3 existing parking spaces to
be delineated for proposed used
car sales display area

B. Aubrey Huffman & Assoc. Ltd.
civil engineering and land surveying
Charlottesville, Virginia

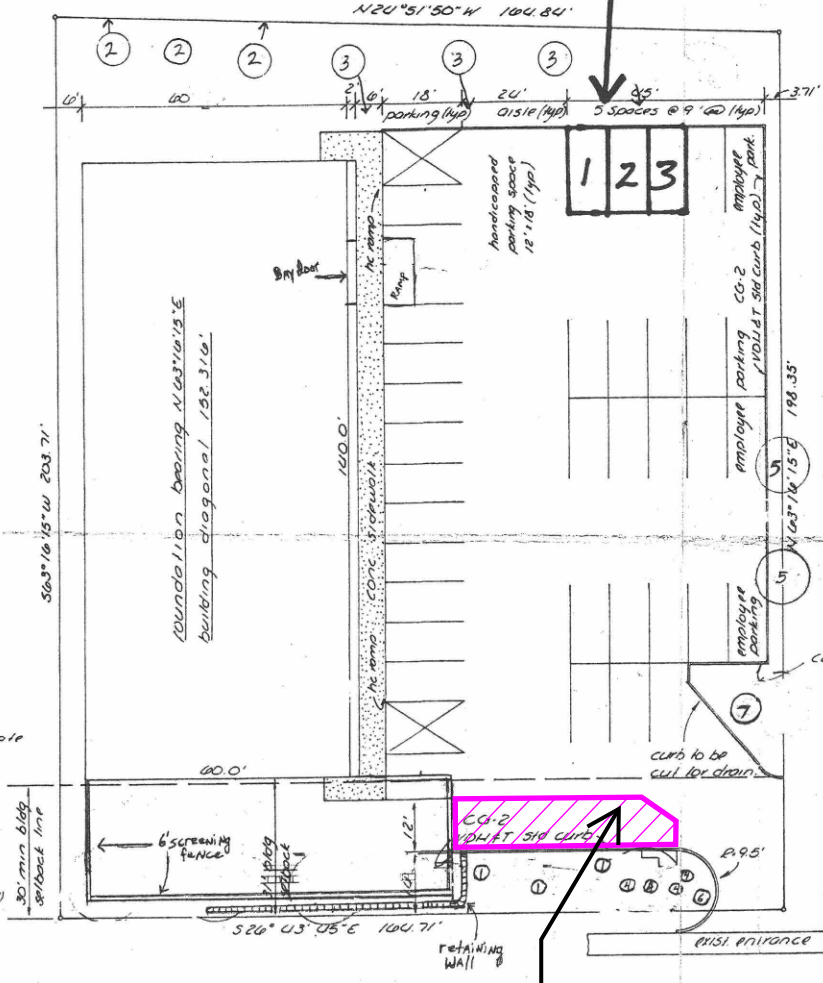
area of
intermittent
parking within
designated
travelway;
staff recommend
pavement
striping, curb
painting, and/or
"no parking"
signage
